CHAPTER VII

Responses to Comments at the Planning Commission Public Hearing on the Draft EIR

Kaiser Permanente OMC Master Plan Project . 204438

Figure VII-6
Project Shadow - 12PM May 21

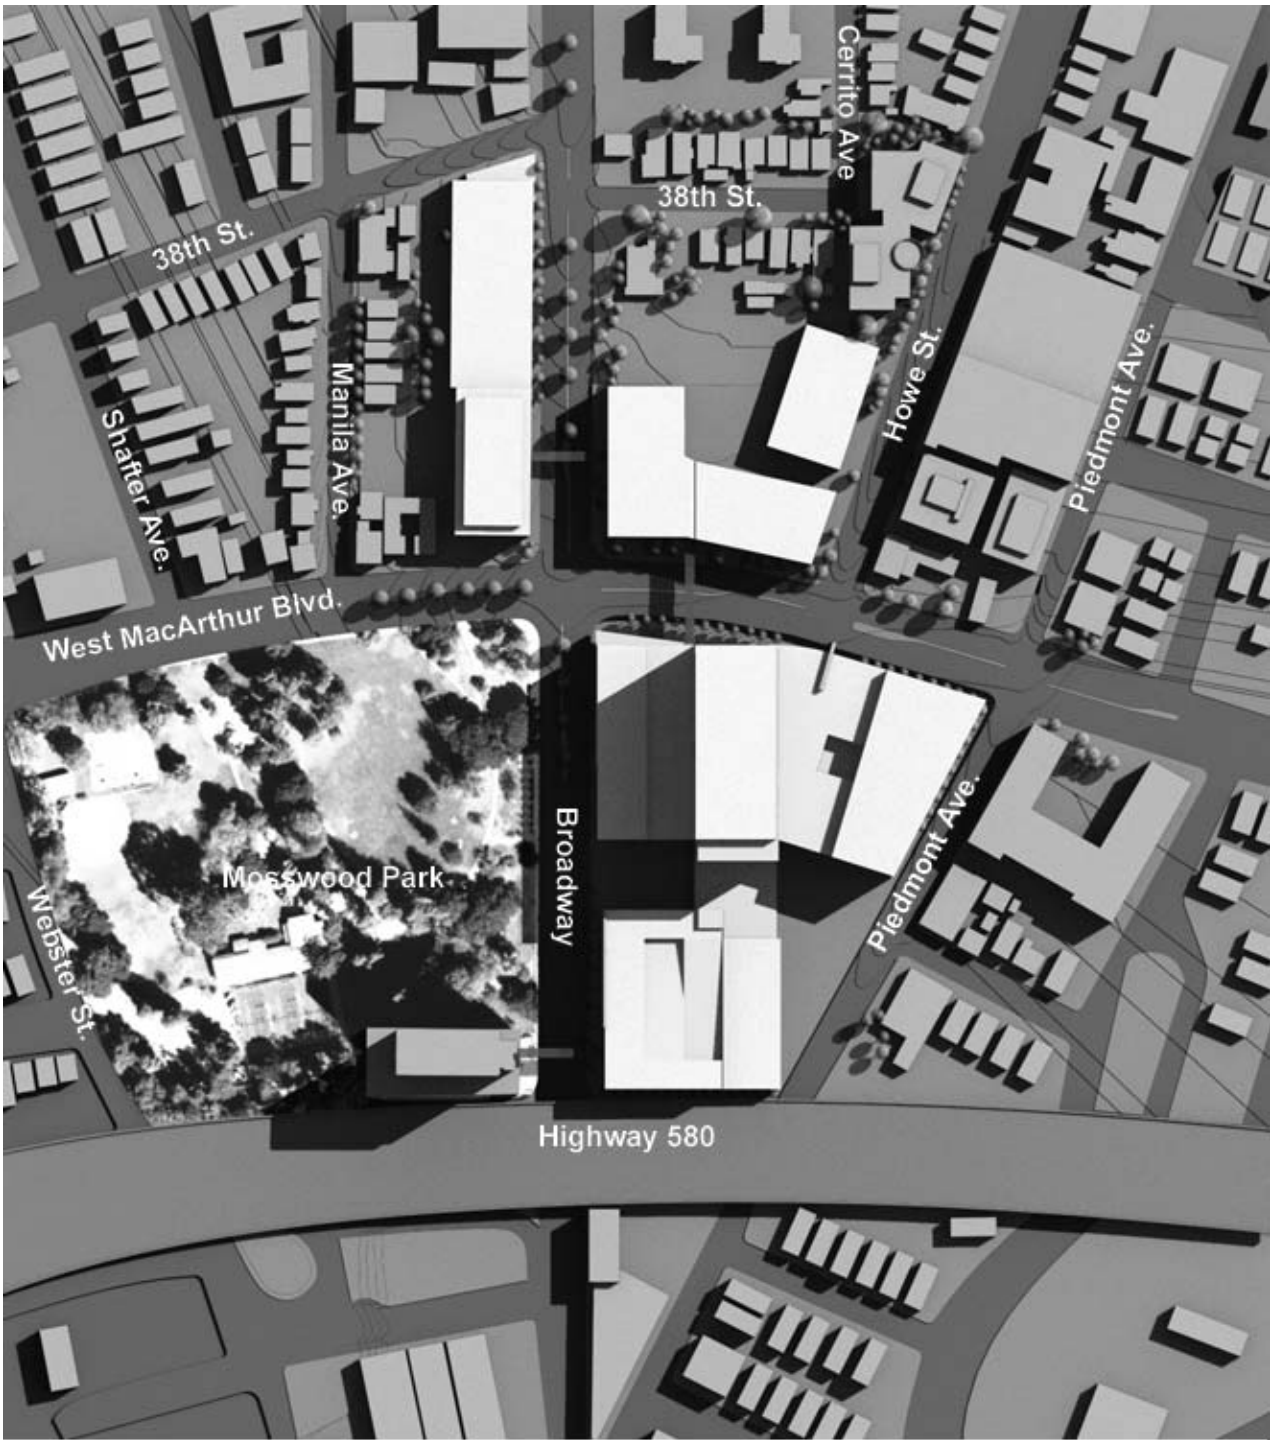
PH-20 Shadow Effects on Mosswood Park Landscaping – A motion that the results of shadow studies on the park shall be evaluated by an independent certified arborist, who shall be engaged to look at the expected impacts on the heritage plantings as well as other landscaping.

Response: In response to the LPAB's motion, a certified arborist has conducted an assessment of the potential effects of increased shading from the project on all trees in Mosswood Park that would be affected by new shadow cast by the project. This assessment is provided in the *Mosswood Park Shading – Tree Shading Impact Report* provided in Appendix D of this Final EIR. This response

Increased Shading. Sunlight is most critical to tree health in the spring season when trees produce their greatest growth. Consistent with the shadow diagrams analyzed in the Draft EIR, during the three months of spring, March 21 to June 21, an estimated 3.5 to 4.5 hours per day of new shading would occur during the morning hours. Coincidentally, the annual worst case period of increased shading on Mosswood Park (resulting from the Replacement Hospital and Garage) would occur in March. Therefore, the assessment of increased shading focuses specifically on shading effects during the spring season.

As documented in Draft EIR Figures IV-K.16 and IV.K-19, Mosswood Park is in full sun in by 9:00 a.m. during spring. For purposes of the detailed analysis presented in this Final EIR, enlarged with-project shadow diagrams of Mosswood Park at key times of day for each of the spring months have been prepared as Figures VII-1 through VII-8 provided at the end of this chapter. The following key project conditions are shown on or interpolated from these figures (as well as those provided in the Draft EIR)

- Mosswood Park is in full sun by at least noon year-round.
- On March 21 (worst study case, i.e., when there is the greatest *increase* in new project shadow compared to existing conditions, in spring and year-round) the park would be in full sun by approximately 10:30 a.m. - approximately 4.5 hours from sun-up.
- On June 21 (shortest shadows, spring and year-round) the park would be in full sun by approximately 9:30 a.m. – approximately 3.5 hours from sun-up.
